SHINE Medical Technologies, Inc.
SMT-2012-017
Project No. 0792

Subject: Response to Request for Additional Information

Response to Request for Additional Information

REQUEST FOR ADDITIONAL INFORMATION SHINE MEDICAL ISOTOPES

Figure 1
The Subcritical Hybrid Intense Neutron Emitter (SHINE)

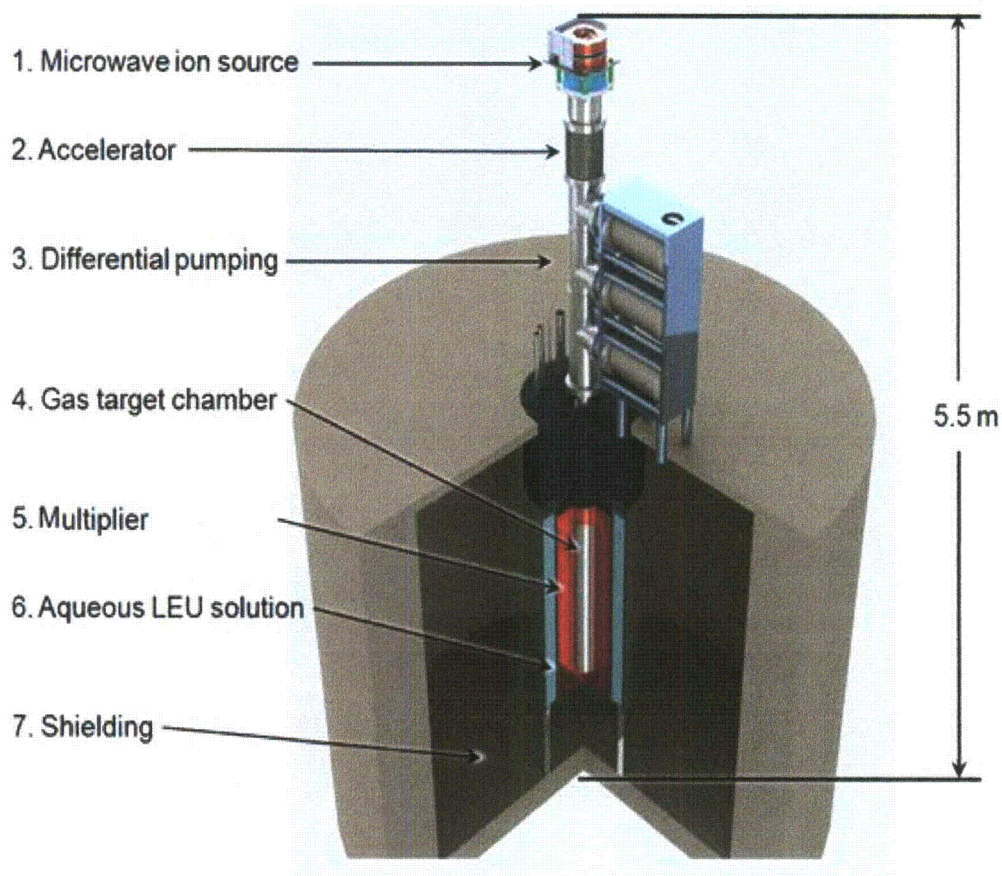
1. A detailed description of the process and equipment which you will be using to make the ^{99}Mo , and that will produce the plutonium. This description should include any information that will allow NRC to determine if your process is a new or novel approach to making plutonium.
2. We would also need accurate projections of the amounts of materials that will be produced in the process. This should include all fission and activation products, including waste stream amounts. How much plutonium and other fission and activation products will be produced per amount of feed material used? How much feed material will be used per batch and per year?

1. At the top of the device (see **Figure 1**), an ion source provides a deuterium ion beam and collimates it to approximately 1 cm^2 .
2. The beam is accelerated by an electrostatic accelerator.

3. The beam passes through the differential pumping sections which serve to keep the accelerator at its working pressure, while maintaining sufficient target gas pressure to produce high neutron yield.

4. The gas target chamber is filled with tritium gas. When the accelerated deuterium ions enter the target chamber, they impact the tritium gas, resulting in nuclear reactions which create neutrons.

5. The neutrons enter a multiplier layer which increases the source neutron population by 2-3 times before entering the target solution vessel (TSV)
6. After multiplication, the neutrons enter the Low Enriched Uranium (LEU) target solution vessel causing ^{235}U therein to fission, creating more neutrons and fission products, including ^{99}Mo . ^{99}Mo accumulates in the solution during the irradiation cycle. The TSV is operated as a subcritical process ($k_{\text{eff}} < 1.00$) at all times.

7. The LEU target vessel is surrounded by a light water pool which reflects neutrons back into the solution vessel, cools the system, and absorbs radiation produced by the device.

8. After several days of irradiation, the solution is removed from the LEU target vessel and ^{99}Mo is separated, purified, tested, and packaged for shipment to $^{99\text{m}}\text{Tc}$ generator manufacturers.
9. The LEU target solution is returned to the TSV for another irradiation.
